## ADDENDUM #3

**Date Issued: March 27, 2018**

**NEW HAVEN PUBLIC SCHOOLS  
SCHOOL CONSTRUCTION PROGRAM**

**10 BUS ENTRY OVERHANG**  
 1 1/2" = 1'-0"

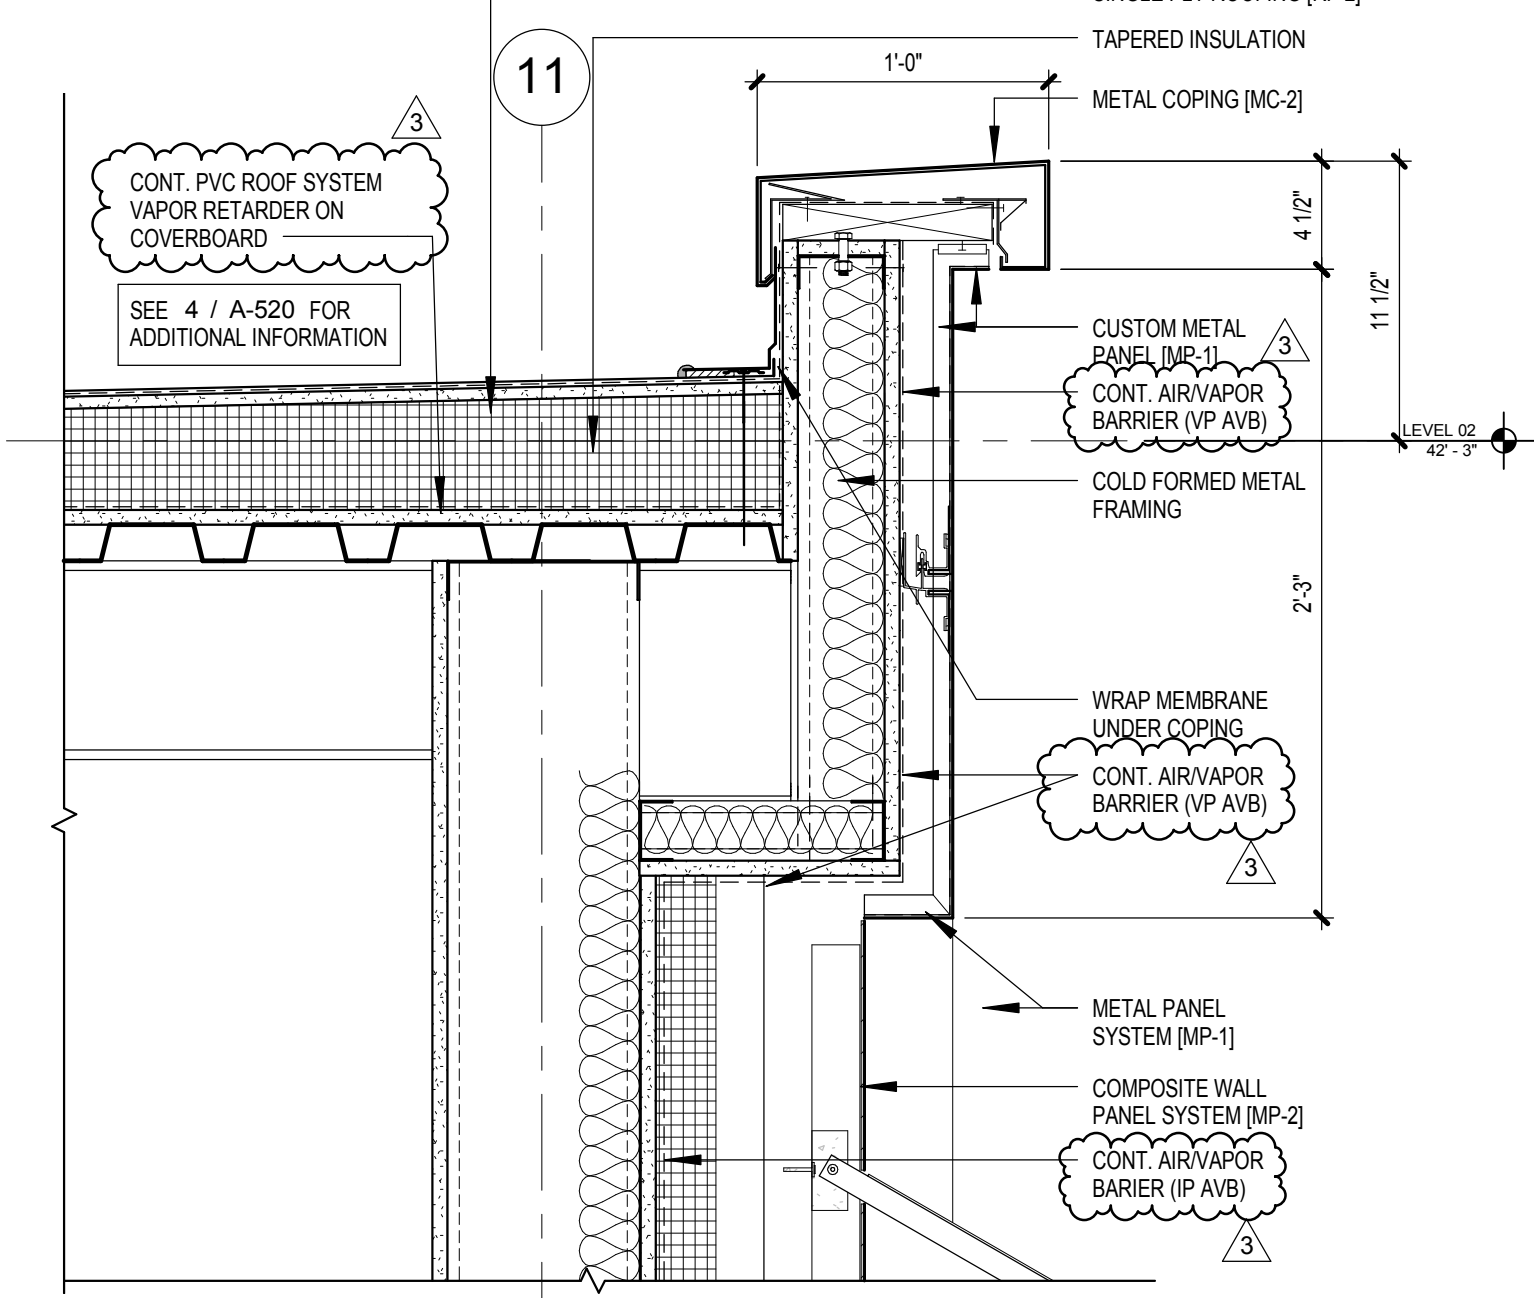
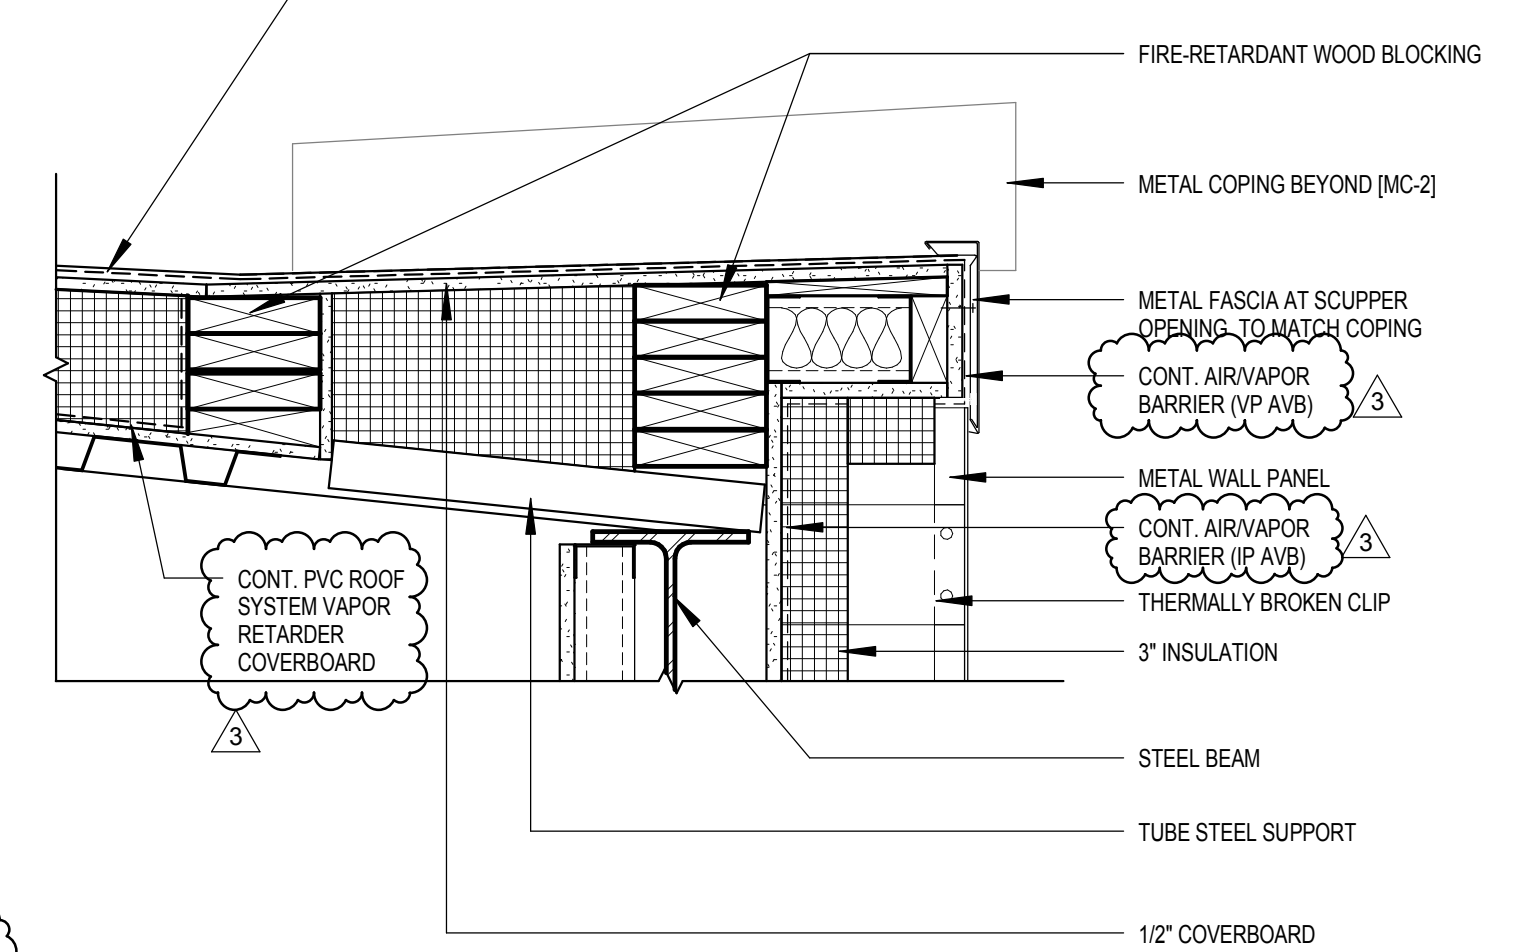
- A-324: Revised elevation 2 to add horizontal mullions at glazing panels.
- A-327: Added call out for detail 21/A-550.
- A-327: Revised detail 1 to match blow up detail 4/A-503 and added call out on typical condition.

See attached from specified manufacturer for section 084113.13. Frames on drawing A324 exceed their max height size.
